## Summary and Evaluation of NTS Site Visit

17-19 May 1982

The Nevada Nuclear Waste Storage Investigations (NNWSI) were organized in 1977 for the purposes of conducting waste-management research at the Nevada Test Site (NTS) and investigating NTS as a potential repository site. I visited NTS on 17-19 May 1982 as part of an NRC team to review the current status of repository investigations at NTS. The purpose of this trip was to prepare NRC staff and contractors to review the Site Characterization Report (SCR) and subsequent licensing documents and to permit exchange of information and ideas between the NRC and DOE programs.

Figure 1. The Candidate Repository Area, Showing Borehole Locations

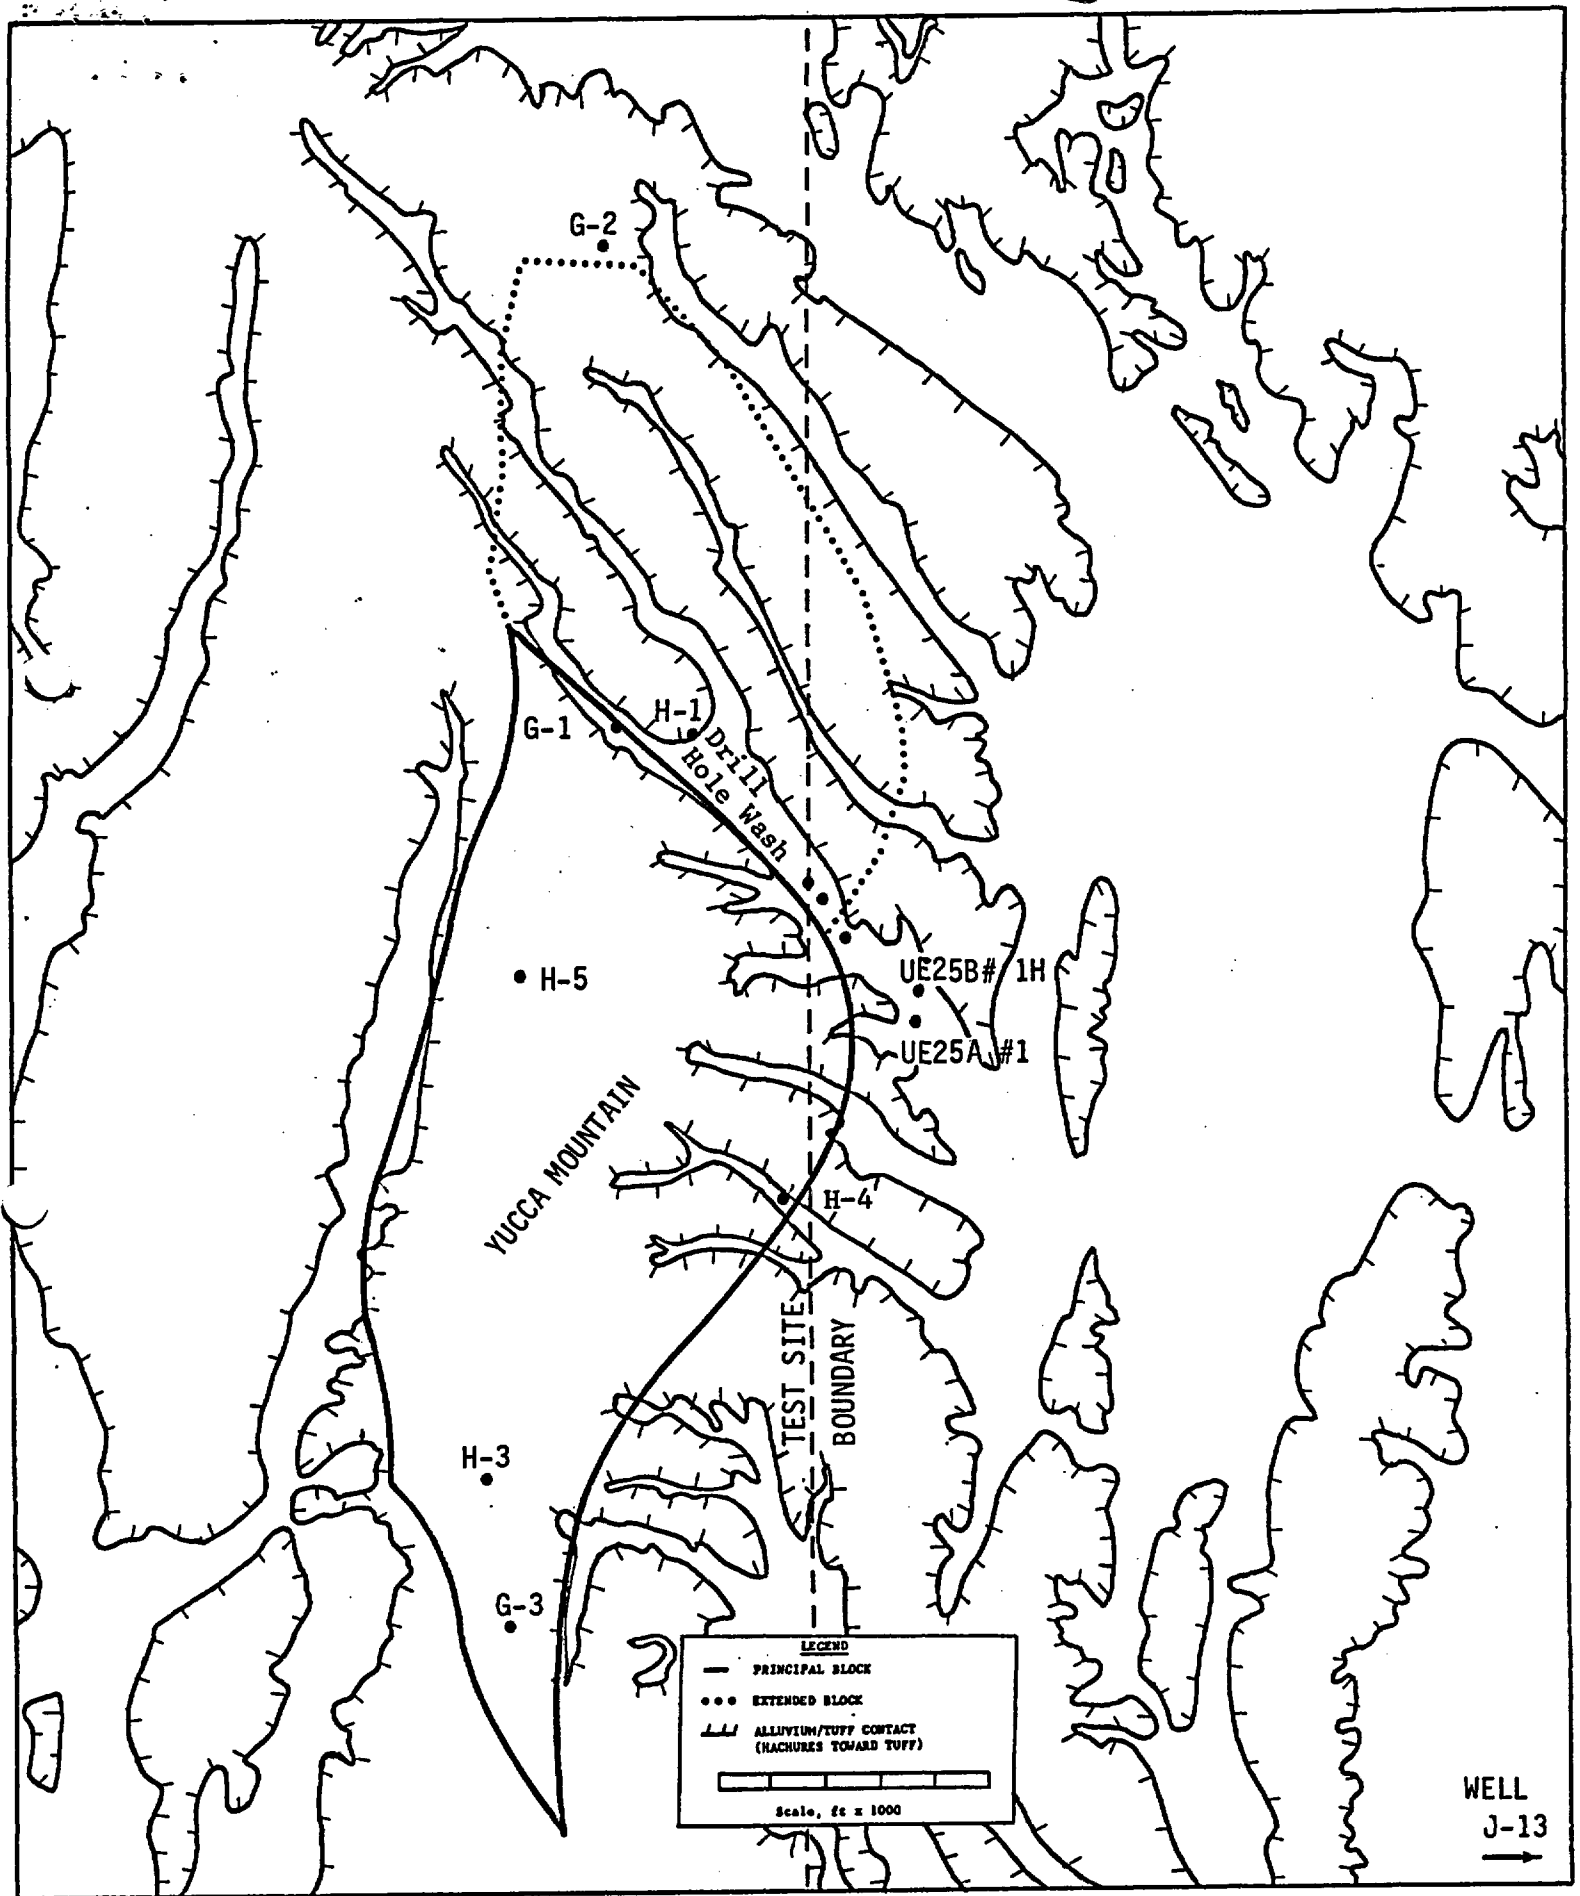
After examining several areas in the Test Site area, NNWSI has chosen a candidate area on Yucca Mountain, at the southwestern edge of NTS. The candidate area, shown in Figure 1, is a structural block, most of which lies just outside the Test Site. If the repository is located in the vadose zone, another area just to the north may also be considered as part of the repository area.

A drilling program is now under way on the edge of the block. Approximate locations of past and planned future boreholes are shown on the figure. The drilling program is planned to circle the block; locations in the center of the area are being avoided to prevent damage to the integrity of a future repository. Construction of a test shaft, which will be in the central portion of the area, is to begin next year.
